CHANGE ORDER

No. 2

Contract: Willowridge Drainage Pump Station

WORK CHANGE DIRECTIVE

PUMP STATION PLAN
 SCALE: 1/8"=1'-0"

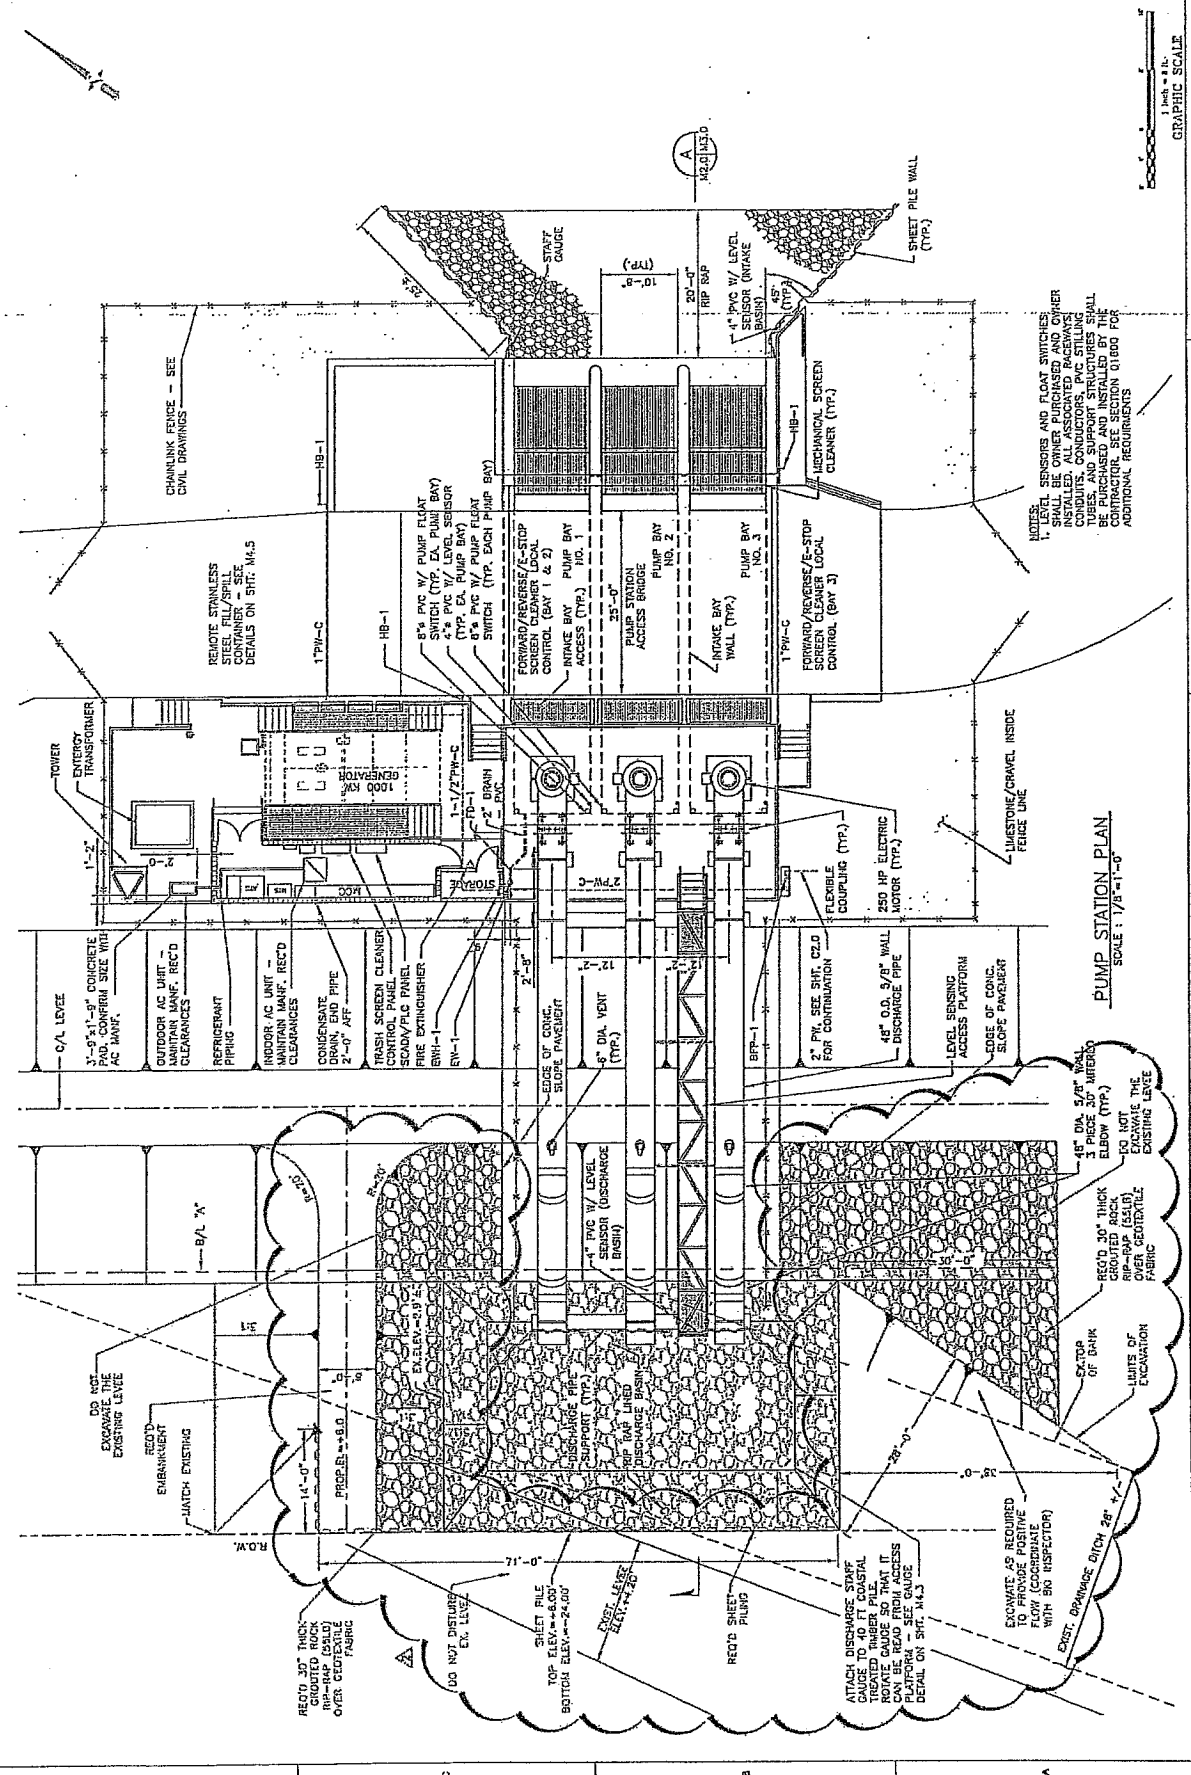
1. Contractor to drive sheet piles provided by the Owner in the discharge basin to prevent erosion on the property line and ensure flow path to existing natural drainage canal. Contractor to drive sheets using equipment currently on site, no additional cost for mobilization or demobilization.

Description: Contractor to drive sheet piles provided by the Owner in the discharge basin to prevent erosion. Contractor to use crane currently on site.

Attachments: Proposal from Sealevel Construction Inc., Dated 8/31/16.
Sheet M2.0, Pumping Station Plan Rev 2 "Work Change Directive - 8/24/16"

New Contract Item 60: Drive owner provided sheet piles QTY: 2,550 SF, 12.90\$/SF, \$32,895.00 total.
